Project	<b>IEEE 802.16 Broadband Wireless Access Working Group</b> < <a href="http://ieee802.org/16">http://ieee802.org/16</a> >	
Title	<b>Enhancements for AAS support in IEEE 802.16-REVd</b>	
Date Submitted	<b>2003-11-07</b>	
Source(s)	Yigal Leiba Zion Hadad Yossi Segal Itzik Kitroser  Runcom Ltd. Hachoma 2 St. 75655 Rishon Lezion, Israel	Voice: +972-3-9528440 Fax: +972-3-9528805 <a href="mailto:yigall@runcom.co.il">yigall@runcom.co.il</a> <a href="mailto:yosis@runcom.co.il">yosis@runcom.co.il</a> <a href="mailto:zionh@runcom.co.il">zionh@runcom.co.il</a> <a href="mailto:Itzikk@runcom.co.il">Itzikk@runcom.co.il</a>
Re:	Working Group re-circulation Ballot #13a Announcement	
Abstract	Enhancements for AAS support, to enable operation in degraded S/N environment with improved dynamic response of the antenna array	
Purpose	Adoption of proposed enhancement into P802.16-REVd/D3-2003	
Notice	This document has been prepared to assist IEEE 802.16. It is offered as a basis for discussion and is not binding on the contributing individual(s) or organization(s). The material in this document is subject to change in form and content after further study. The contributor(s) reserve(s) the right to

Figure aaa

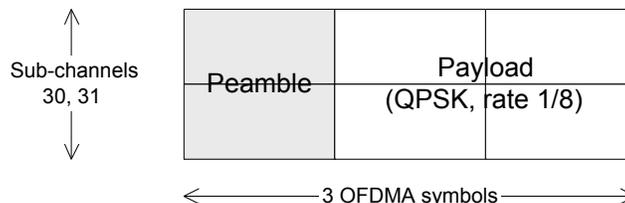
Comment type	Starting page	Starting line	Fig./Table	Section
	Technical, Non-binding	457	32		8.4.4.7
<b>Comment</b>	In high S/N conditions, synchronization based on DL preamble alone may not suffice

Sub-channels 30 and 31 of the DL frame may be dedicated at the discretion of the BS for active AAS scanning. When these sub-channels are used for this purpose, they shall not be allocated in the normal DL\_MAP message.

These sub-channels will be used to transmit the AAS\_DL\_SCAN\_IE(), whose physical construction is shown in figure aaa. The AAS\_DL\_SCAN\_IE() is transmitted with a well known modulation and coding, namely QPSK rate \_ with 4 repetitions.

The AAS\_DL\_SCAN\_IE() is transmitted by the BS with in a specific direction of the AAS beam, and includes a preamble to facilitate channel equalization by the AAS SS. The preamble used in sub-channels 30, 31 is defined in section 8.4.6.1.1, and shall be selected to have the same segment number as the DL frame preamble, and the cell ID shall equal  $(DL\text{-Preamble cell-ID} + 16) \bmod 32$ .
